SUBJECT: ISSUANCE OF AMENDMENT NO. 101 TO FACILITY OPERATING LICENSE NO.
DPR-28 VERMONT YANKEE NUCLEAR POWER STATION (TAC NO. 65338)

Amendment No. 101
License No. DPR-28

SAFETY EVALUATION BY THE OFFICE OF NUCLEAR REACTOR REGULATION
SUPPORTING AMENDMENT NO. 101 TO FACILITY OPERATING LICENSE NO. DPR-28

ATTACHMENT TO LICENSE AMENDMENT NO. 101

Figure 6.1.2
PLANT OPERATIONS ORGANIZATION

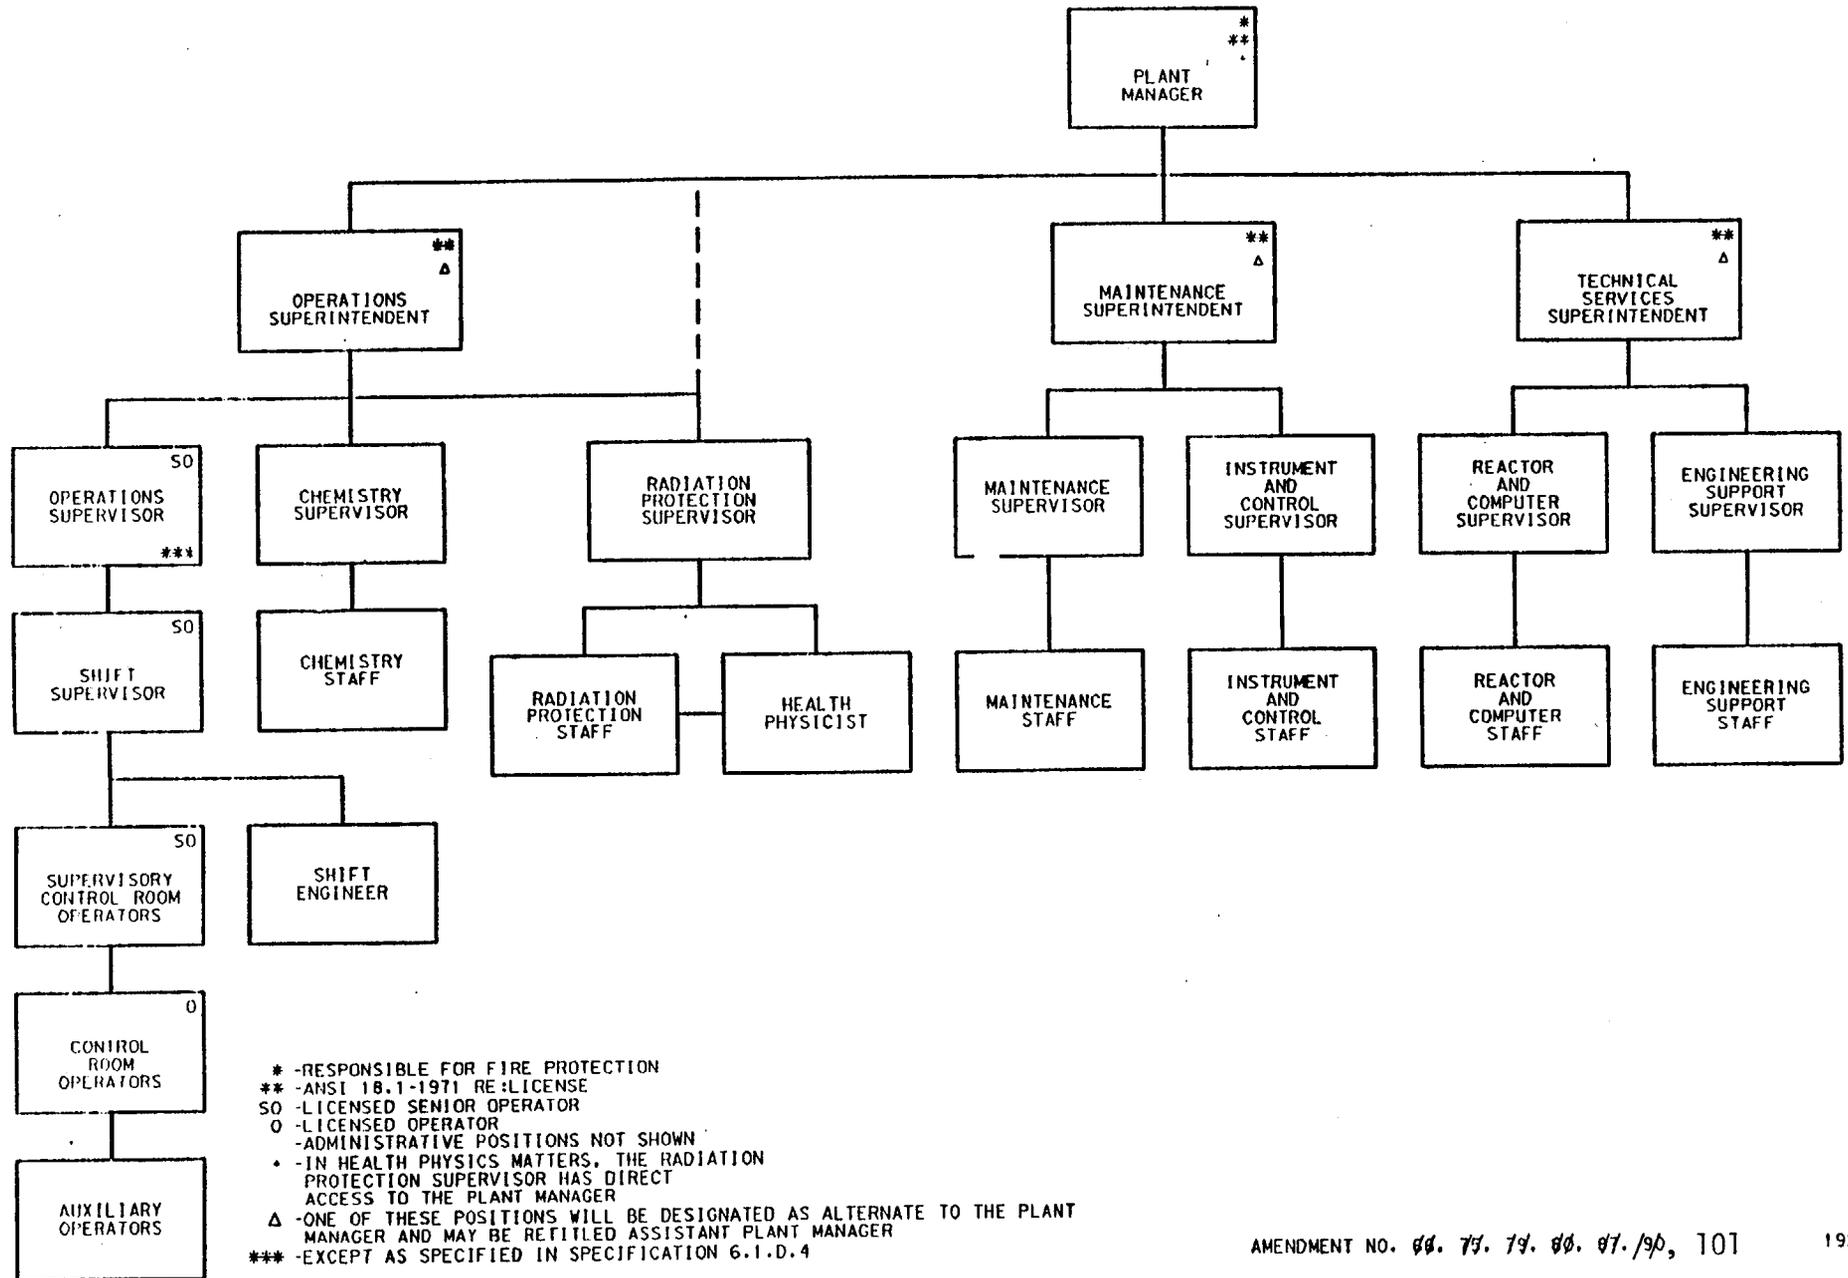
2.1. Figure 6.1.2 - Plant Operating Organization

The plant operating organization has been revised by splitting the Chemistry and Health Physics Department into two separate departments: the Radiation Protection Department and the Chemistry Department.

We find this change acceptable because it meets the acceptance criteria of Sections 13.1.2-13.1.3 of NUREG-0800, Standard Review Plan.
